SERVICE BULLETIN

M-1098

XL GEARCASE GASKETS

Figure 1. 2000 Cam cover and gasket

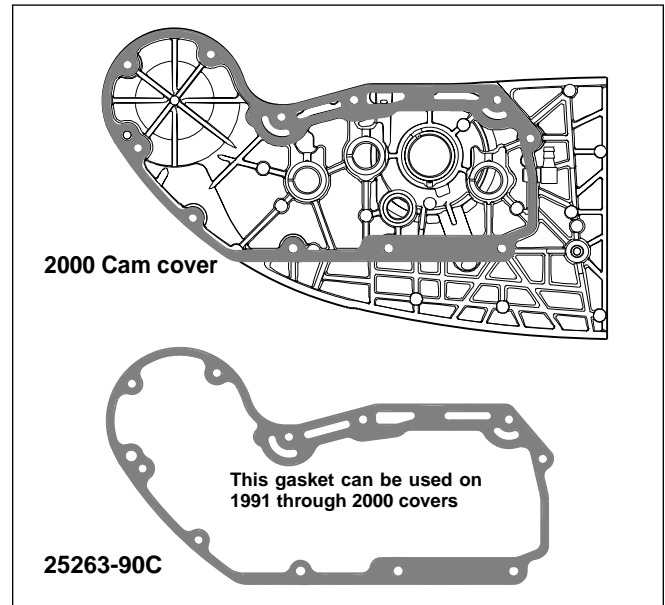
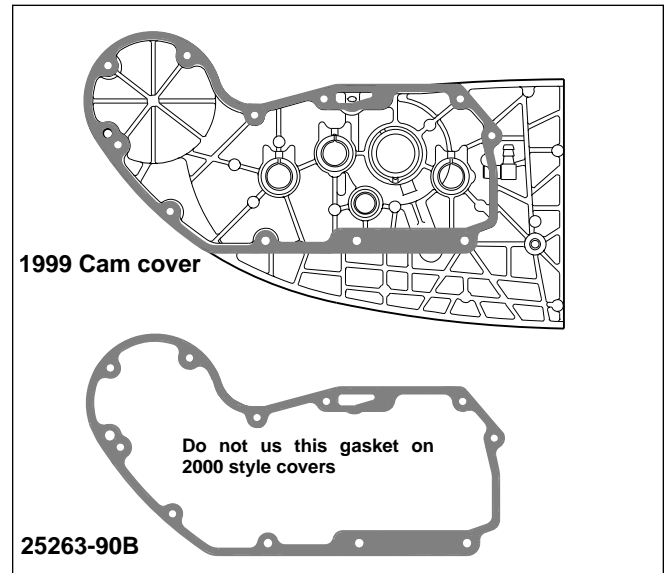
Late production 1999 Sportster and Buell engines use the model year 2000 gearcase cover and gasket. If the cover is removed and re-installed, care must be taken to install the correct gasket, or oil starvation can occur. The 2000 gasket (25263-90C) **MUST** be used with the 2000 style gearcase cover.

If a 25263-90B gasket is installed on a 2000 style gearcase cover, oil starvation can occur to the top end. Oil starvation can result in engine damage.

Model Year 1999 XL Motorcycles with engine numbers XX99-158-XXX to XX99-176-XXX have the 2000 cam cover and must use 25263-90C.

The XL engine gasket kit 17026-91B has superseded to 17026-91C. The 17026-91C gasket kit contains the 25263-90C cam cover gasket.
